(Progress Inspection) REPORT (hereinafter called the "Report")

Report Number 01744

Inspection Date: 17/03/2023

Property Address: Sample street

QBCC Standards & Tolerances 2.3 Site Drainage

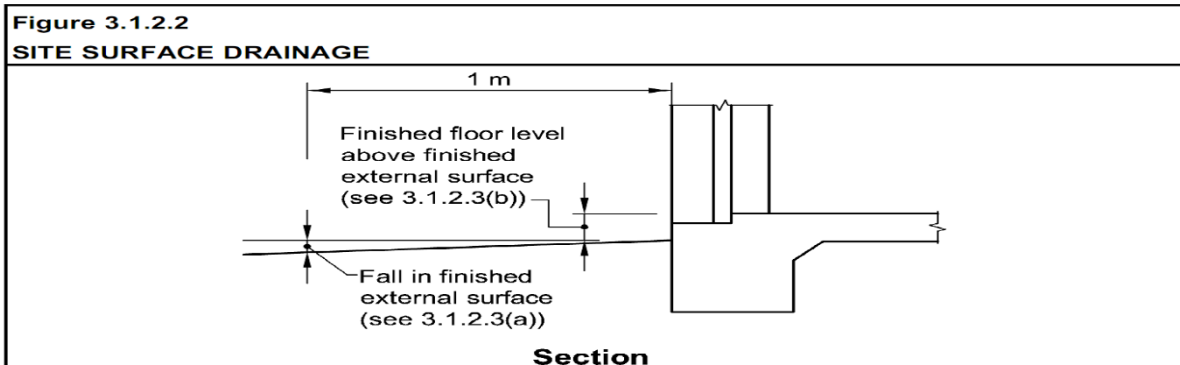
1. Ground levels, surface water drainage inadequate and temporary downpipes are not connected this can cause water to lay against the footings. This must be maintained throughout the build regardless of if the owner is doing the landscaping or not. As per 3.1.2.3 BCA and the QBCC Standards & Tolerances. We do acknowledge this is works in progress.

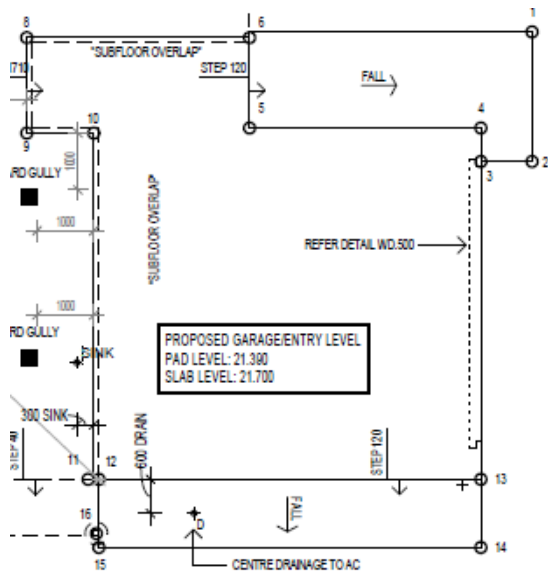
2. Poor housekeeping site rubbish unsafe. **Trip hazard.**

Many slips, trips and injury are the results of poor housekeeping, and this is often a sign of a lack of storage, maintenance and cleaning. This should be cleaned as soon as possible.

Fig. A1 Plumb of walls

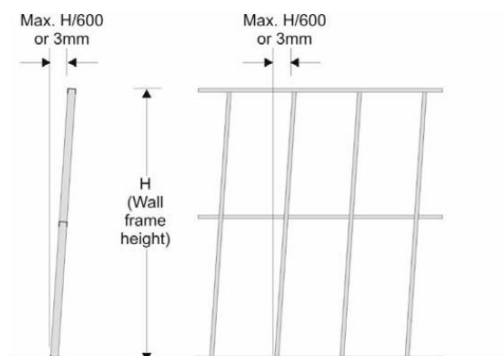
8. Frame out of plumb, this will need to be rectified.

NASH Standard Part 2; 2.2.3: - Walls shall be plumb to within $H/600$ or 3mm as detailed in Figure A1.

Steel wall frames to this building have not met this requirement.

Walls must not deviate from the vertical by more than $H/600$ or 3 mm whichever is greater where H is the height of the wall as shown in Fig. A1.

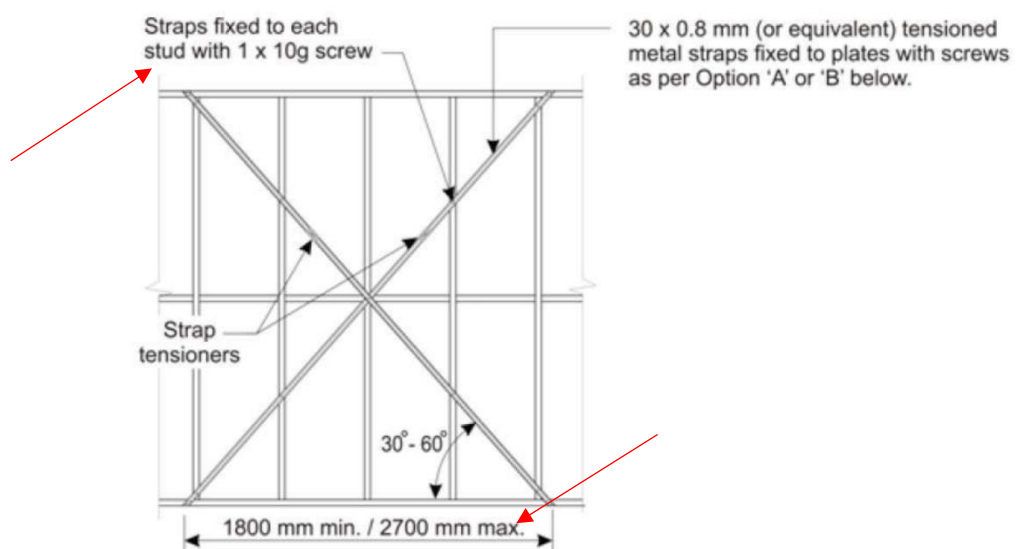
9. The frame has been damaged, substandard finish, this will need rework, not in an appropriate, skilful way or with reasonable care and skill need to be rectified.
As per NASH 1.13 insert

Framing materials and accessories must be stored and transported in such a manner as to prevent hazards to persons and damage to the materials.

7.9 FLOOR JOIST TO BEARER – SINGLE/UPPER STOREY

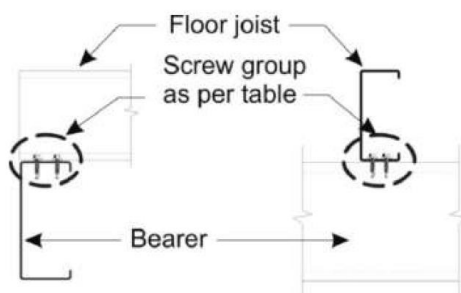
16. It appears that there are a number of joists that haven't been screwed off to the load bearing walls as marked, see insert below.

- A number of fixings to bearers to the joists have not been completed and are in the wrong location for fixings, the brackets for the floor joist are in the wrong location.
- Front entry, subfloor joist, not connected to bearers cantilevering, no connection to intermediate bearers PFC. This will need to be rectified.

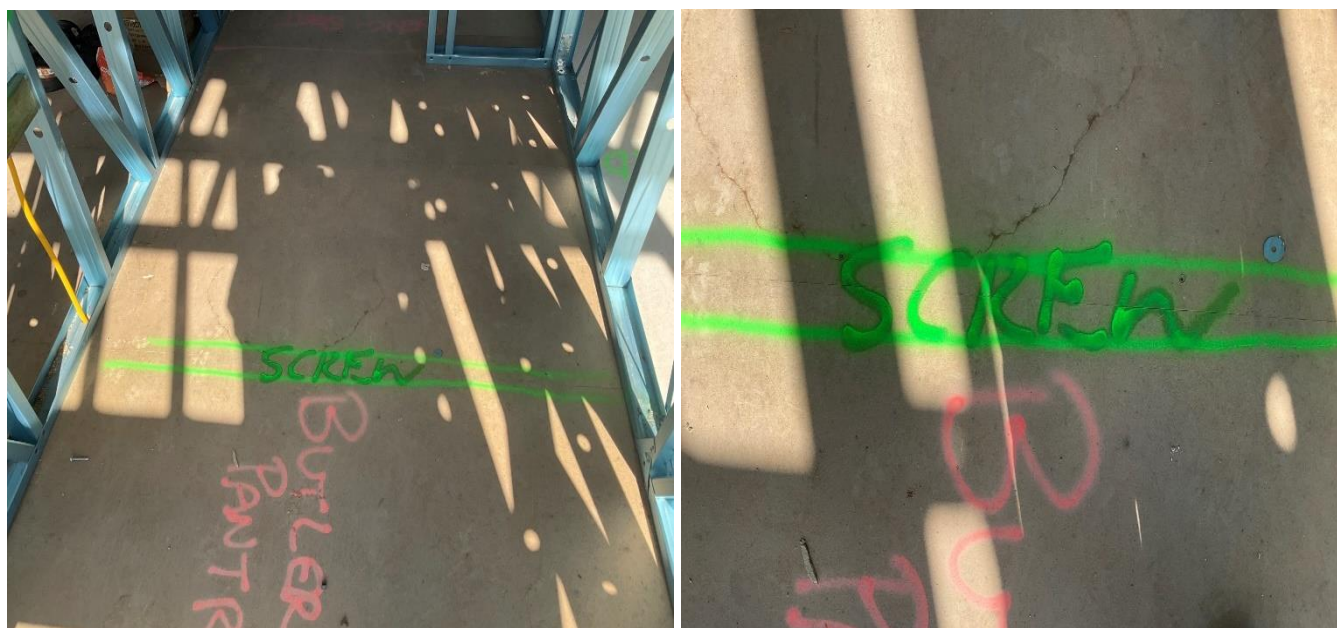
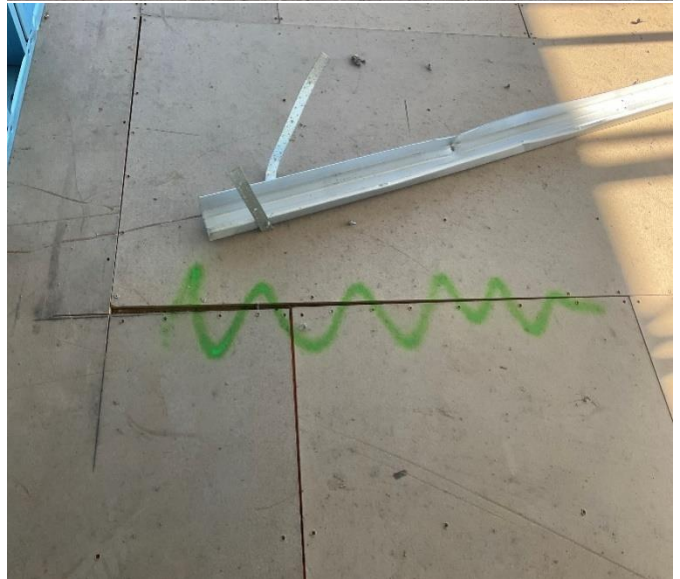
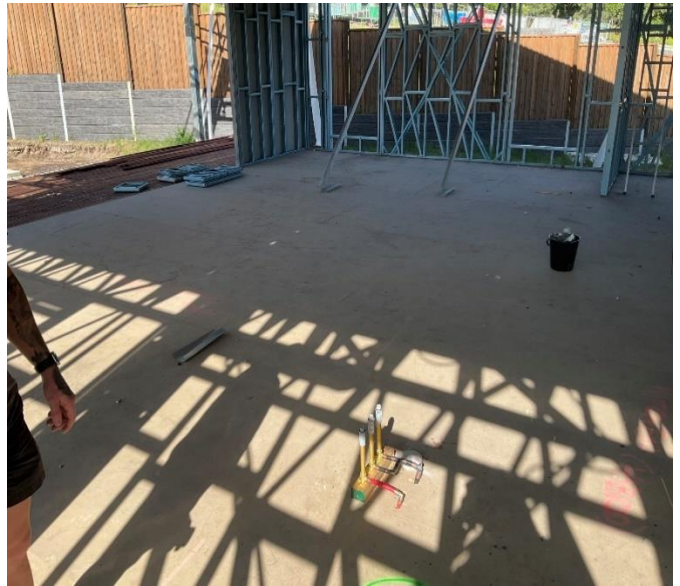
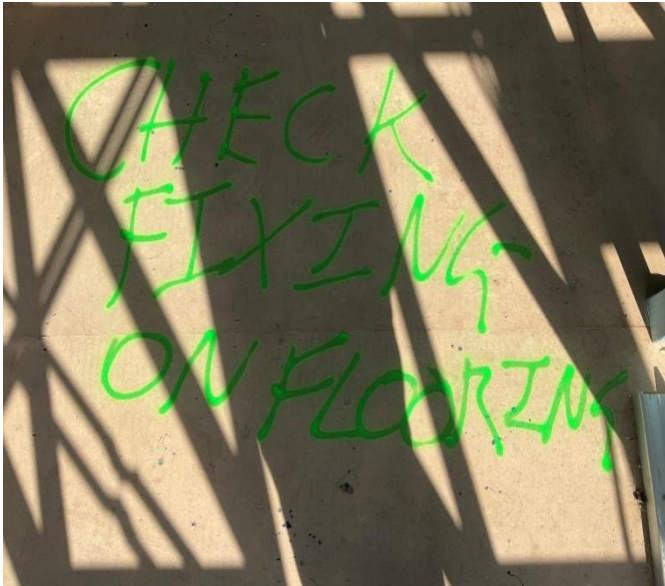
17. The particleboard flooring has not been installed as per the manufacturer & as per AS 1860.2

- Missing screws.
- Screws over driven.
- Close to the edge.
- Humps and dips/ out of level.
- Damage
- Excessive gaps.

AS 1860.2, 10.4 Screws; The screws over driven should be adjusted to drive the screw head 2mm to 3mm below the panel surface to allow for later sanding. Screws should not be driven more than 3mm below the panel surface.

- (a) *For square-edged panels—*
 - (i) *along edges and ends—*
 - (A) *spacing—*not exceeding 150 mm centres; and
 - (B) *distance—*not closer than 10 mm to any edge; and
 - (ii) *on intermediate joists—*not exceeding 300 mm centres.
- (b) *For tongued and grooved panels—*
 - (i) *along the edges—*
 - (A) *spacing—*at joist crossing, 300 mm centres; and
 - (B) *distance—*not closer than 10 mm nor greater than 25 mm to the base of the groove; and
 - (ii) *along the ends—*not exceeding 150 mm centres and not closer than 10 mm to the edge.

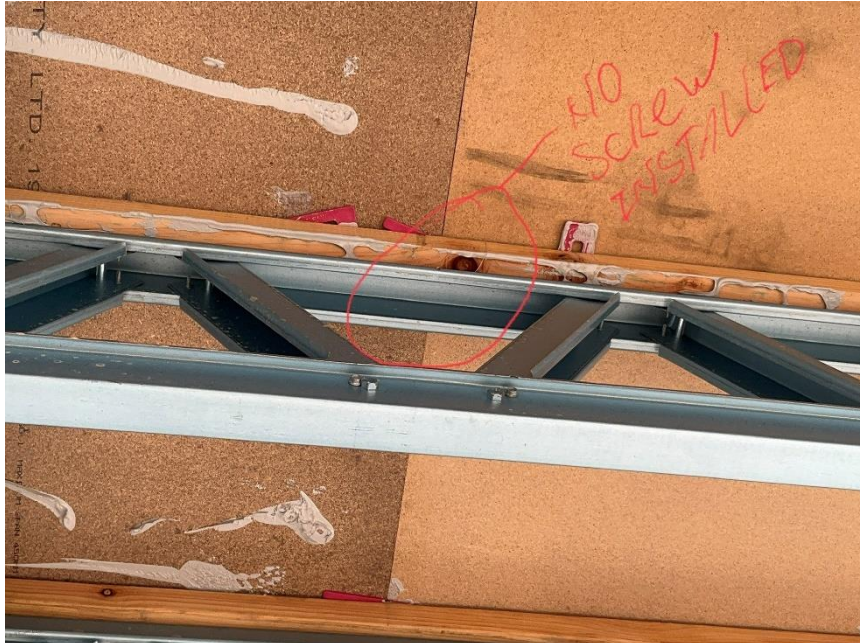
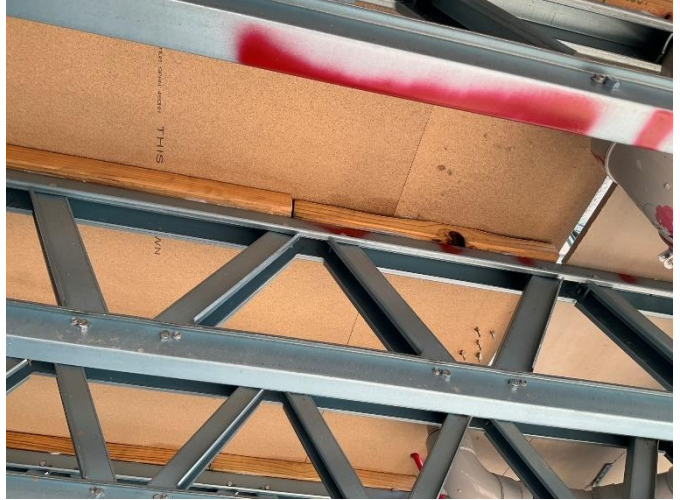
18. Subfloor and frames have used window packers for structural support, these may not be fit for this purpose; these structural members are not fully supported.

This will need rework, not in an appropriate, skilful way or with reasonable care and skill. All needs to be reworked to comply with the Nash standard as per insert:

For load bearing walls, gaps between the bottom plate and the concrete slab greater than 3 mm must be packed with load bearing shims or grouted at each stud. For non load bearing walls gaps greater than 3 mm must be packed with load bearing shims or grouted at jamb studs and points where the bottom plate is fastened to the slab.

For the attachments of floor joists, bearers, trusses and rafters to walls, where the gap is over 3 mm, the gap must be packed with load bearing shims.

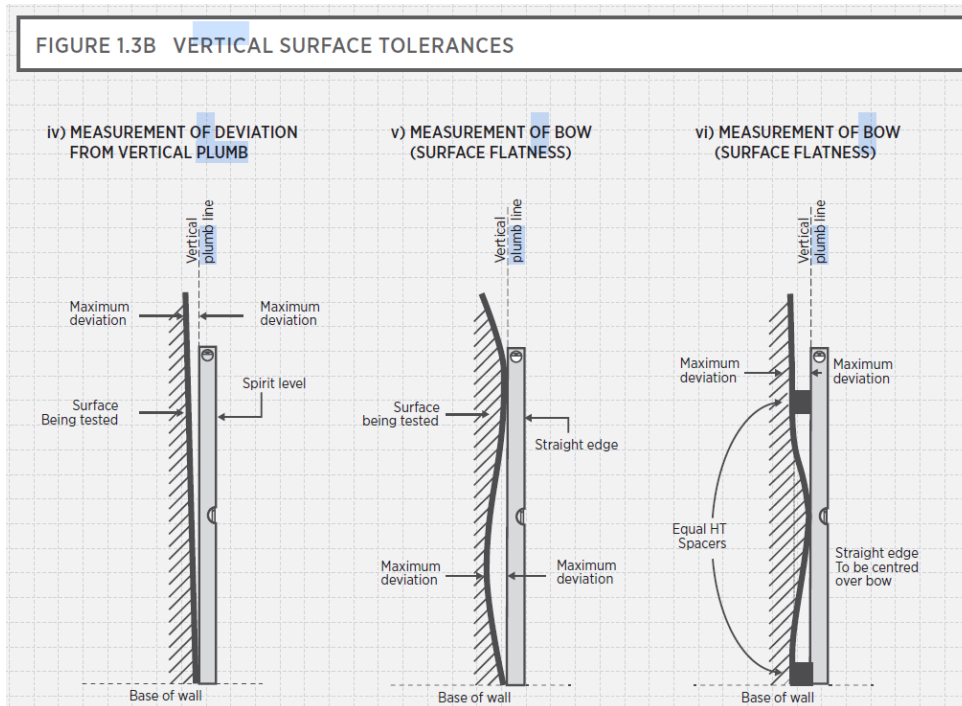
20. Subfloor post supports not plumb, this will need to be rectified.

Walls exceed the allowable allowance as marked; this will need to be reworked. We refer the builder to the insert below.

QBCC Standards & Tolerances 5.2 verticality or plumbness of timber frames and exposed posts; Within the first 12 months from completion of the work, post and wall frames are defective if they deviate from vertical by more than 4mm within any 2m height. Refer to figure 1.3B in this guide for method of measurement.

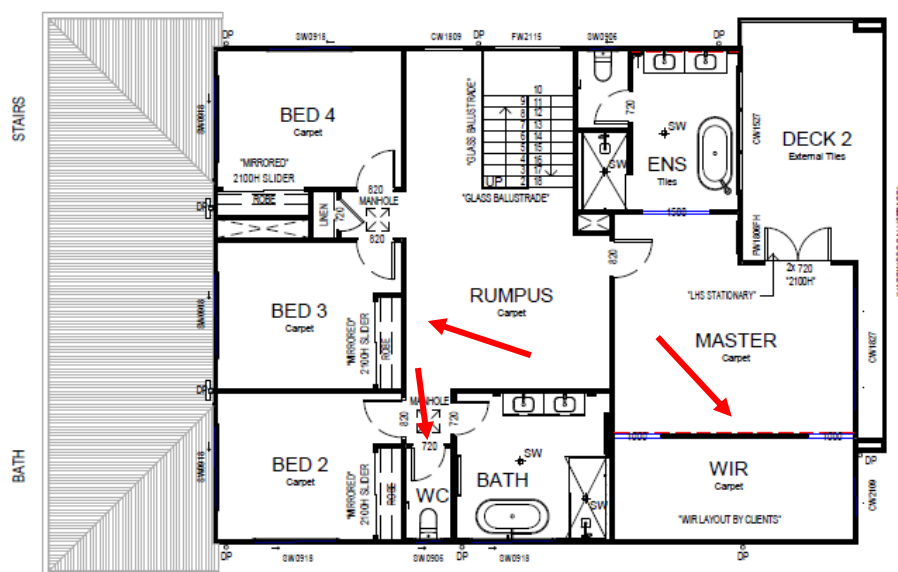
22. Non load bearing walls are missing wall brackets- This will need to be reworked.

As per the **3.3.3 NASH Standard; Mitek Manual**; Non load bearing walls must be kept a minimum of 15mm below the underside of the bottom chord of the roof truss, roof beams roof rafters, floor members or ceiling battens when used and fixed with vertically slotted wall brackets. Wall brackets also must be no more than 1800mm apart. This is a requirement also detailed in the 2014 Mitek roofing fixing and bracing guidelines. This will need to be reworked.

Non load bearing walls must be kept a minimum of 15 mm below the underside of the bottom chord of the roof truss, roof beams, roof rafters, floor members or ceiling battens when used and fixed with vertically slotted wall brackets..
